ISSUE: Certificate of Appropriateness for signage and Waiver of Vision Clearance

APPLICANT: Mount Vernon Petroleum Realty, LLC

LOCATION: Old and Historic Alexandria District
501 South Washington Street

D PROPOSED PRICE ID SIGN
MONUMENT SIGN DETAIL
ILLUMINATED - LED

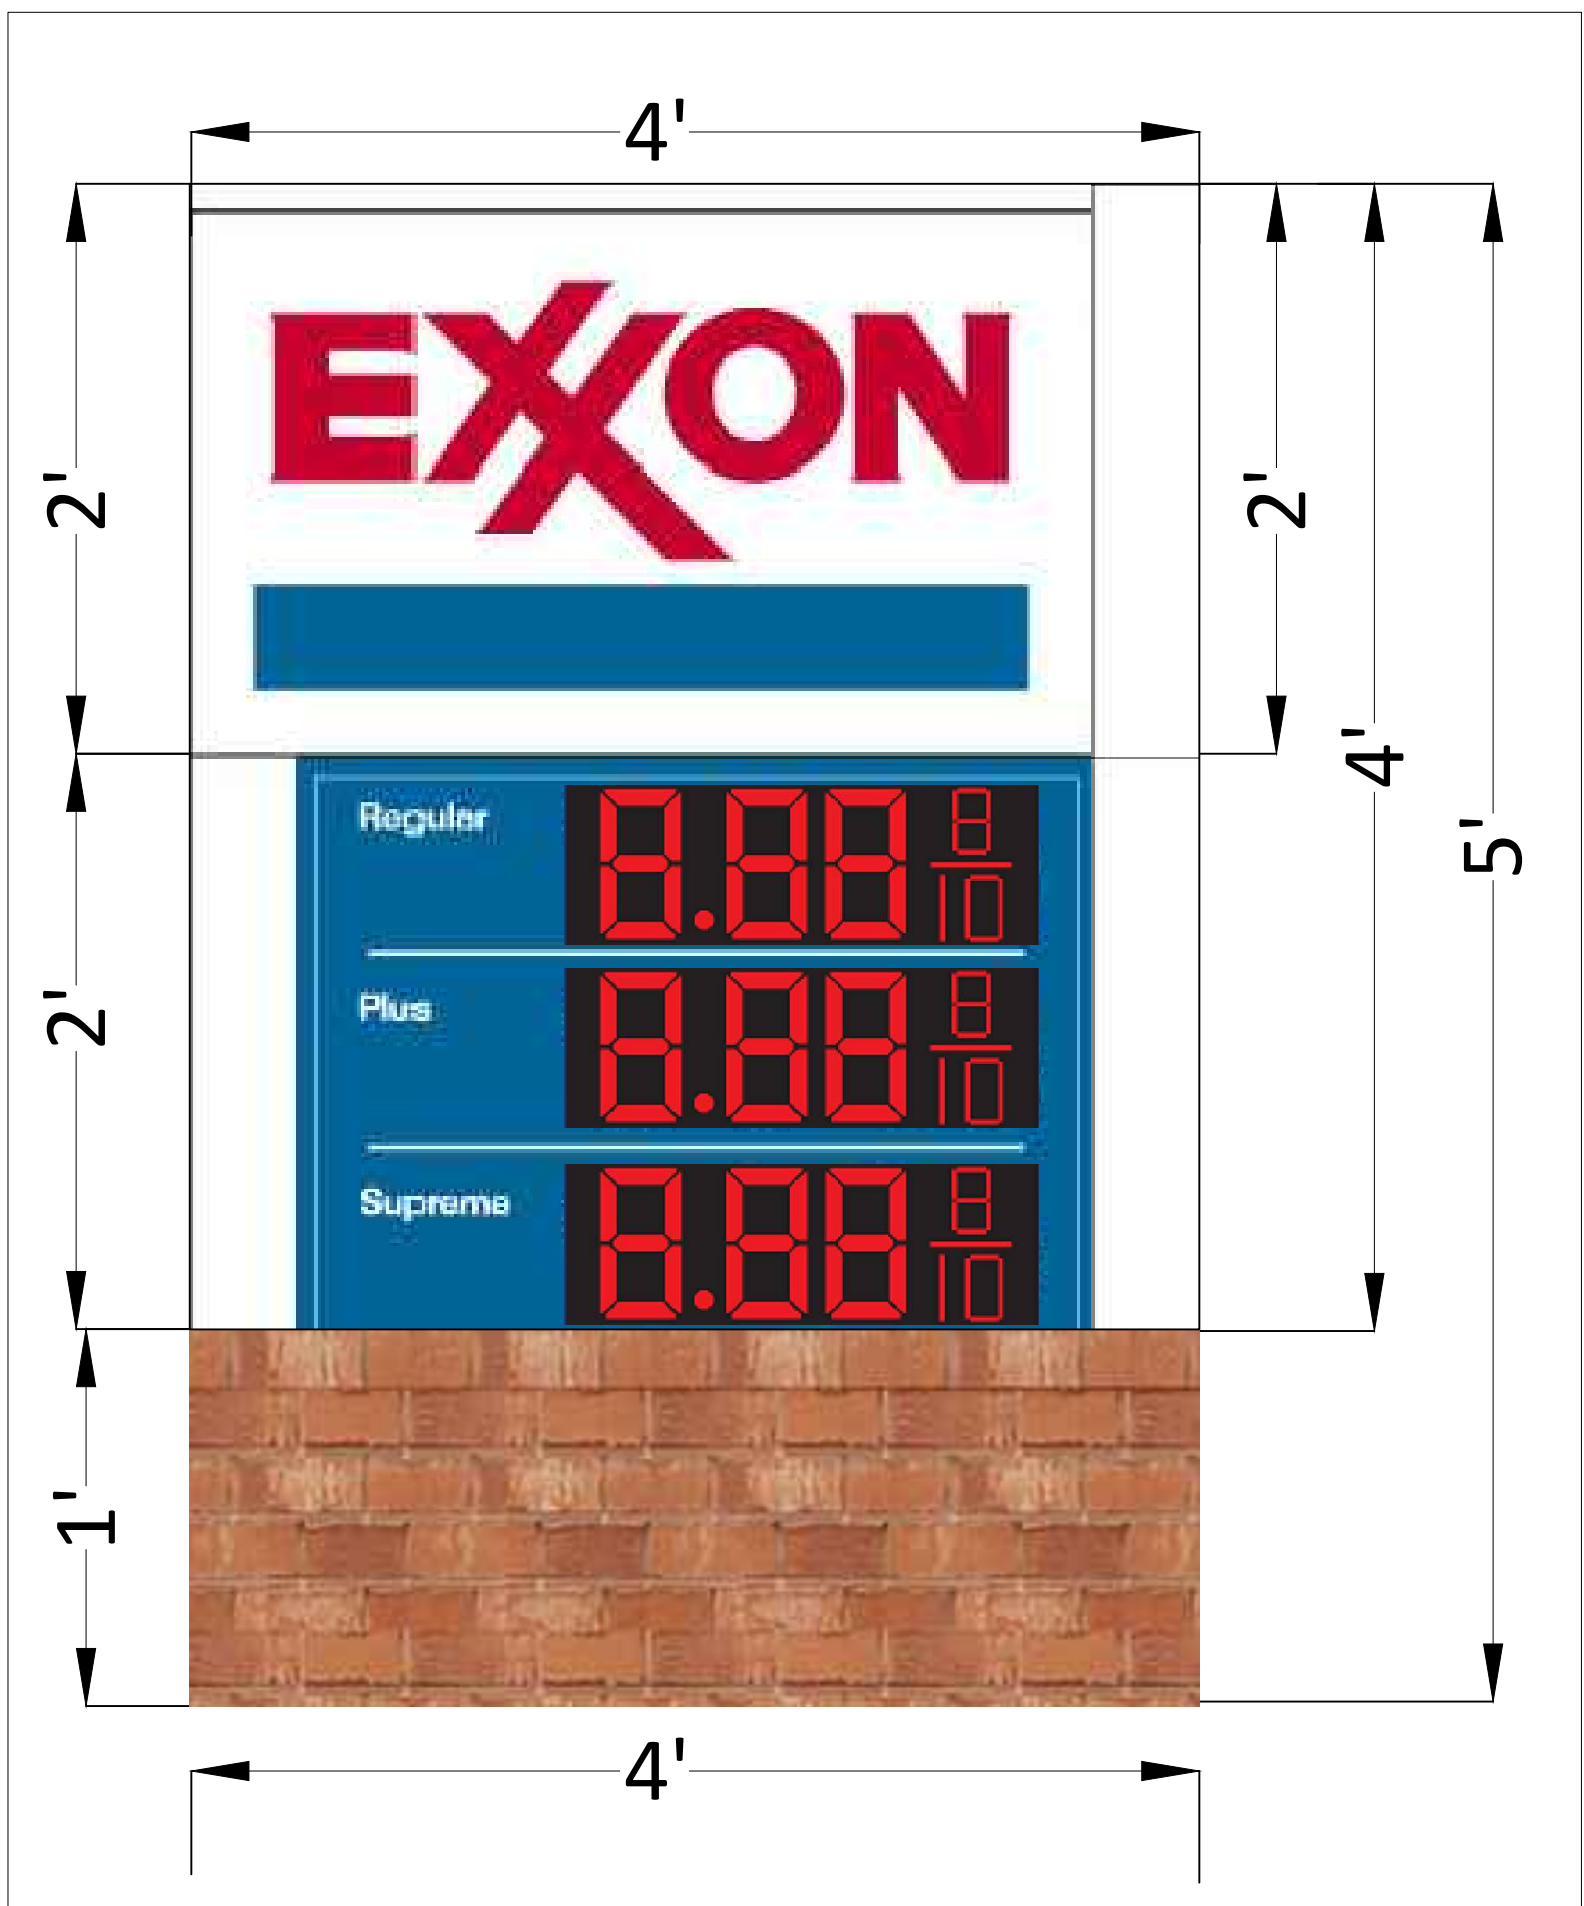
1. No signs on the site may be internally illuminated except for the price numerals on the monument sign, whose intensity is to be reviewed by staff at night in the field to ensure the compatibility of the illumination with the surrounding streetscape.

- The proposed price ID sign as we appreciate the scale of the sign being reduced significantly and the use of a brick base to provide continuity within the historical character of the parkway the illumination of the sign is not appropriate and we would ask you to reconsider the illumination. We would also ask to reconsider the addition of the "Snacks" signage and have that removed from the ID sign.

Therefore, staff recommends approval of the proposed sign plan, with only the price numerals themselves on the monument sign internally illuminated, and with the intensity of the sign lighting be reviewed to by staff at night in the field to ensure the compatibility of the illumination with the surrounding streetscape as is the BAR's standard condition.
